# **Berry and Walker Streets – North Sydney**

Section 4.55(1A)  
Modification Assessment  
(08\_0238 MOD 12)

April 2019

**Figure 3** | Proposed Spring Street Elevation

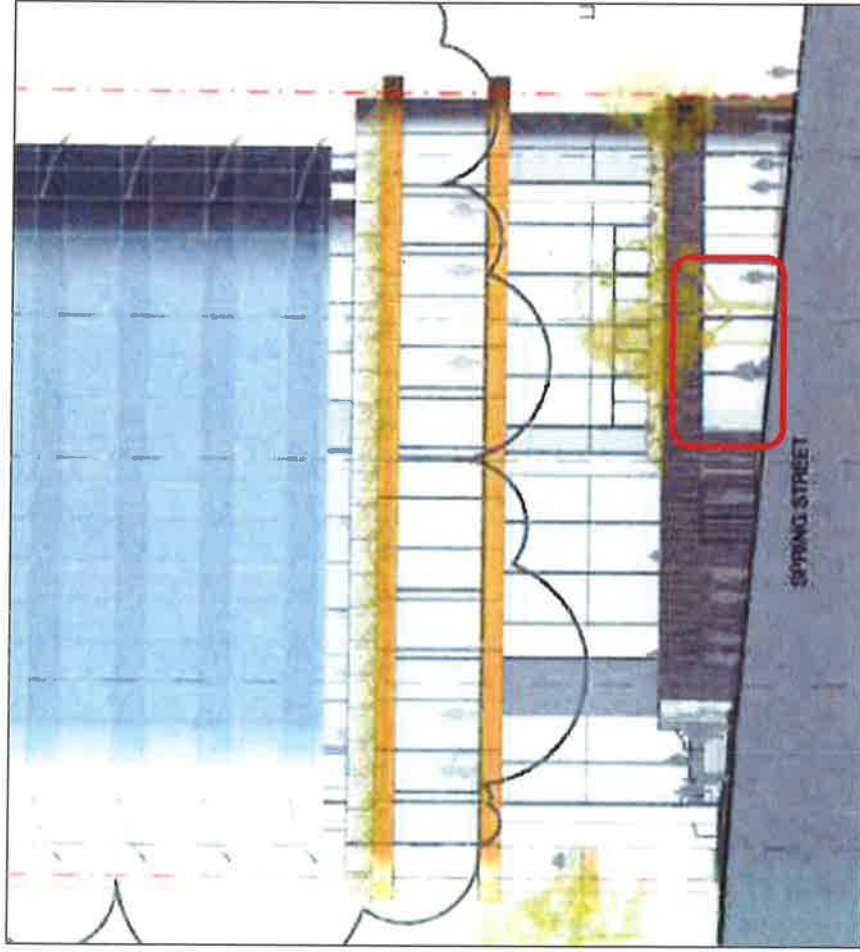
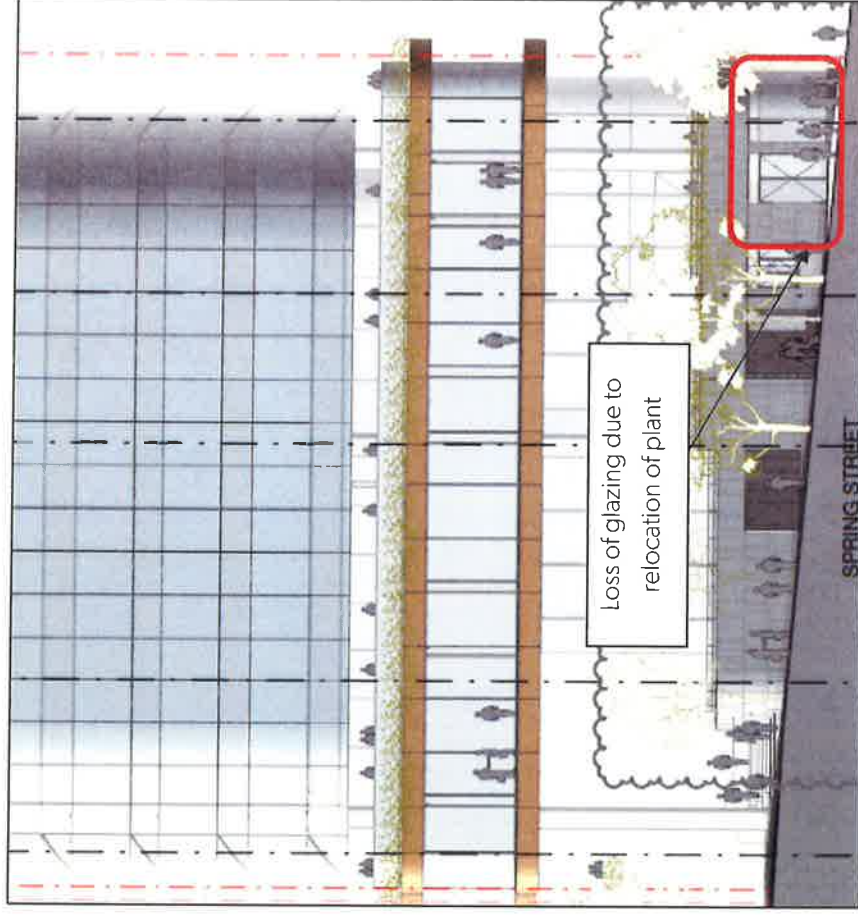
The modification seeks approval to amend the alignment of building services and relocate a gas meter room from the Little Spring Street elevation to the Spring Street elevation.

The Department notes the proposal would result in a minor loss of glazing along the Spring Street frontage, as outlined in **Figures 2** and **3** below.

- the minor loss of activation along Spring Street would be offset by additional activation along Little Spring Street due to the relocation of plant (see **Figures 2** to **5**)
- the portion of glazing lost along Spring Street is minor and would not affect the overall level of street activation along this frontage
- the Proponent has advised the relocation of the gas meter room is required to meet the requirements of the energy provider. The gas line is provided in Spring Street and therefore the gas meter room must be provided on the Spring Street frontage
- Council raised no objection to the proposed relocation of the gas meter room, and associated façade changes along Spring Street.

The Department is therefore satisfied the proposal is acceptable, and would not impact the overall ground level activation.
